UNITED STATES PATENT AND TRADEMARK OFFICE

APPLICATION NO.	FILING DATE	FIRST NAMED INVENTOR	ATTORNEY DOCKET NO.	CONFIRMATION NO.
09/739,975	12/20/2000	Rieko Fukushima	02887.0199	3736

# Office Action Summary

**FIG. 1**

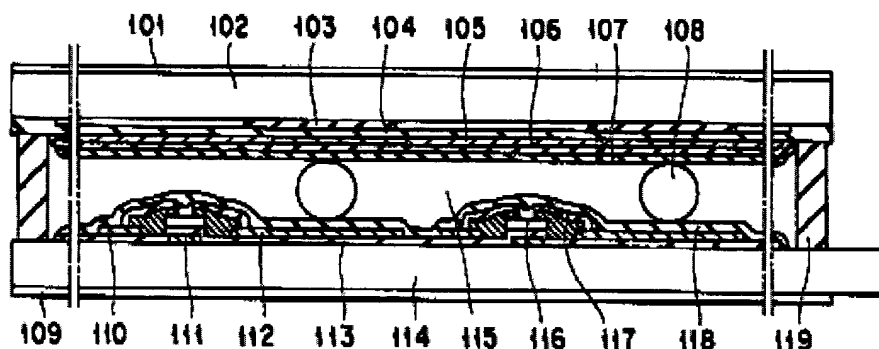
As to claim 8, Saishu discloses in Figure 1 (col. 6, line 60 through col. 8, line 45), a liquid crystal display element comprising: a first substrate, 114; a switching element disposed on said first substrate; a second substrate, 102, counter to said first substrate; a first alignment layer formed over said switching element, 118; a second alignment layer, 107, formed over said second substrate, wherein said first and second alignment layers are rubbed in rubbing directions (col. 7, lines 35-40); a light modulating layer, 115, disposed between said first and second substrates wherein the light modulating layer comprises an anti-ferroelectric liquid crystal material having a thresholdless voltage-transmittance characteristic (col. 7, lines 43-45); and a filter, 104, formed on said second substrate, wherein said filter allows specific wavelengths of light to pass.

Saishu does not explicitly disclose an element wherein the surface tension of each of said first and second alignment layers is between about 49 dyn/cm and about 53 dyn/cm.
